DRB ADMINISTRATIVE SITE PLAN AMENDMENT
 PROJECT NO. 1004343
 PLAN NO. OCAA-01213
 Remove concrete wall to the west of the building
 Planning Director: [Signature]
 DATE: [Blank]

TITLE: ALAMEDA LITTLE LEAGUE FACILITY
 SITE DEVELOPMENT PLAN FOR BUILDING PERMIT - SITE PLAN
 JULY, 2005

PROJECT 1004343
 DRB ADM PLAN AMENDMENT

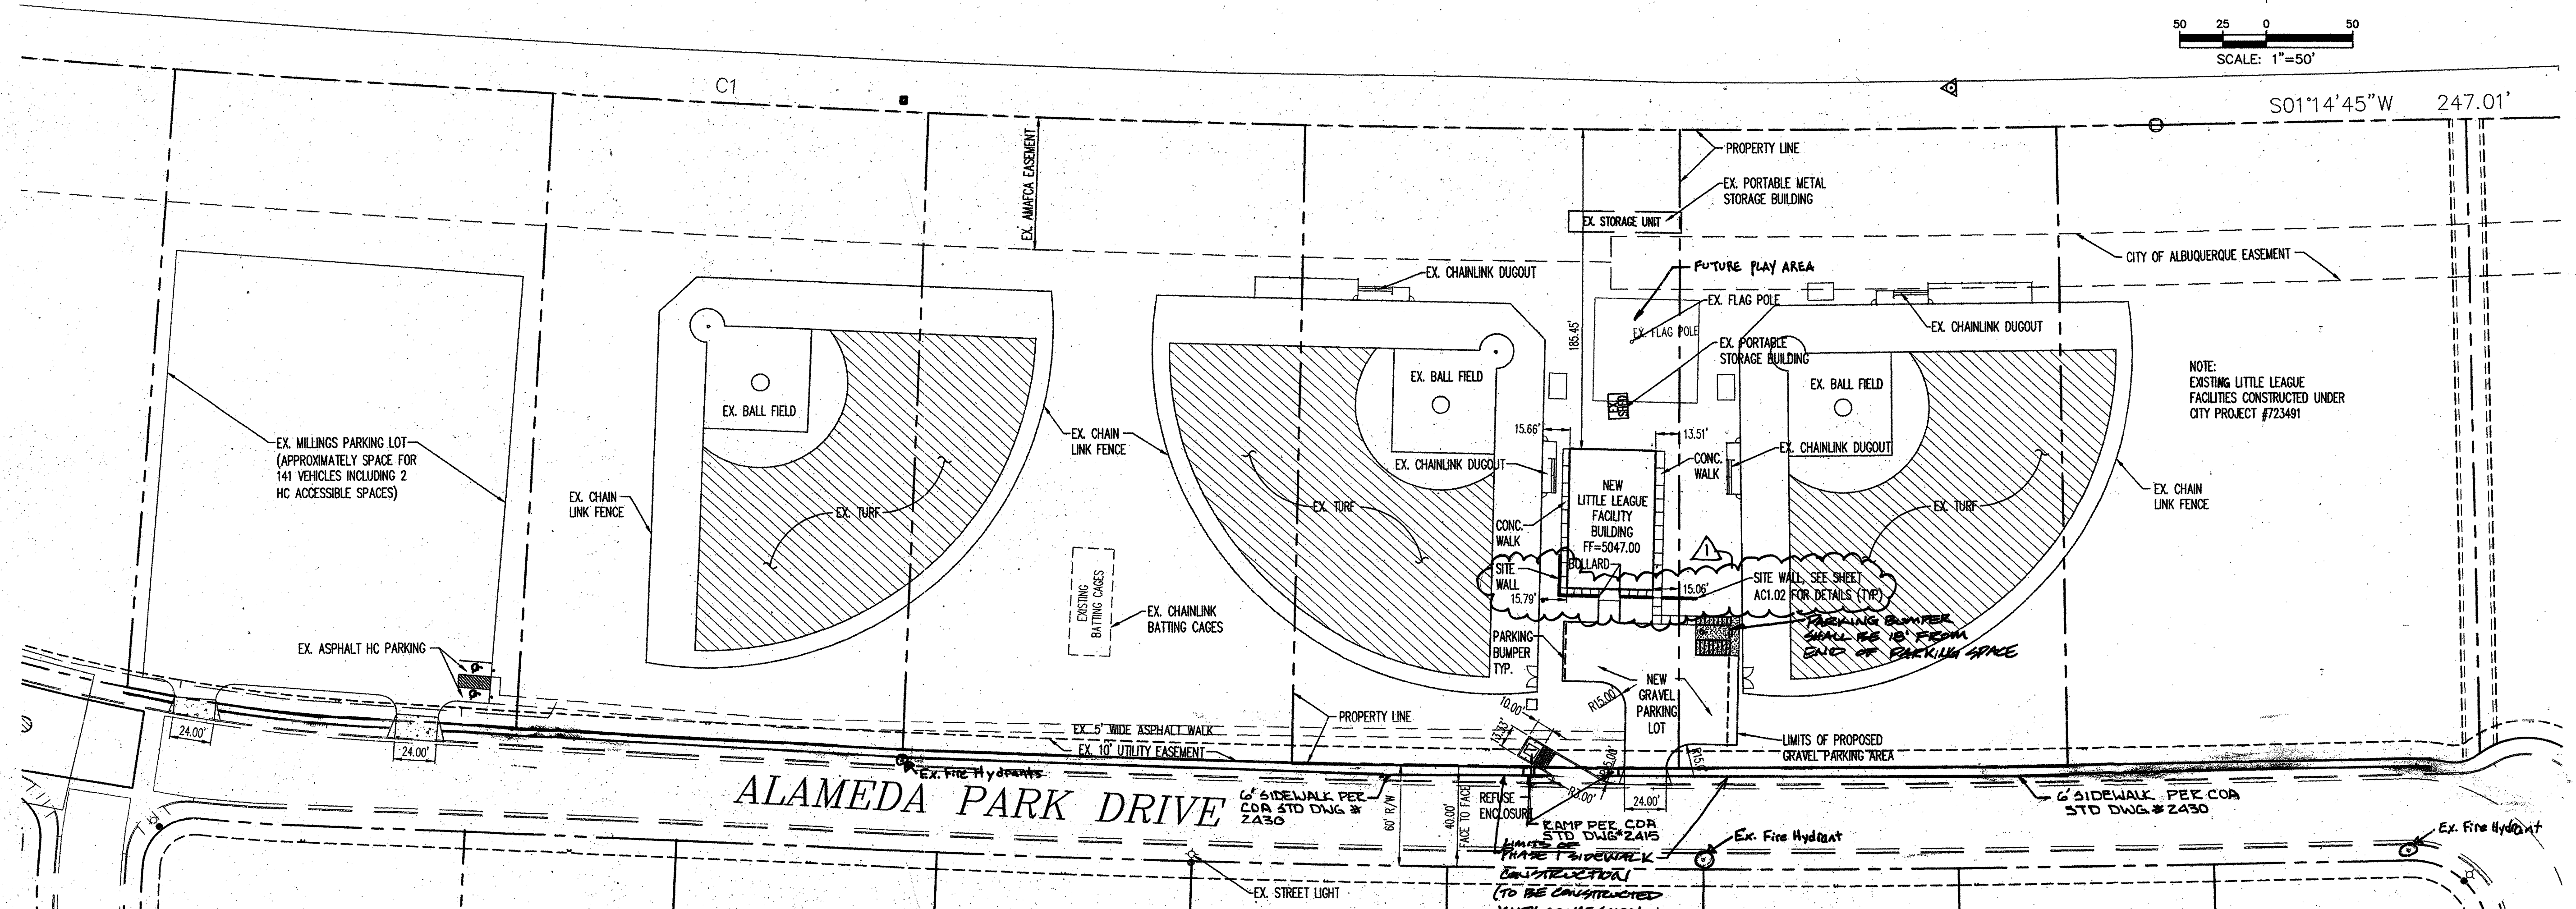
PLANS CHECKING
 924-3611
 APPROVED FOR CONSTRUCTION
 DATE: 11/11/05
 DELETE CMU GITE WALL
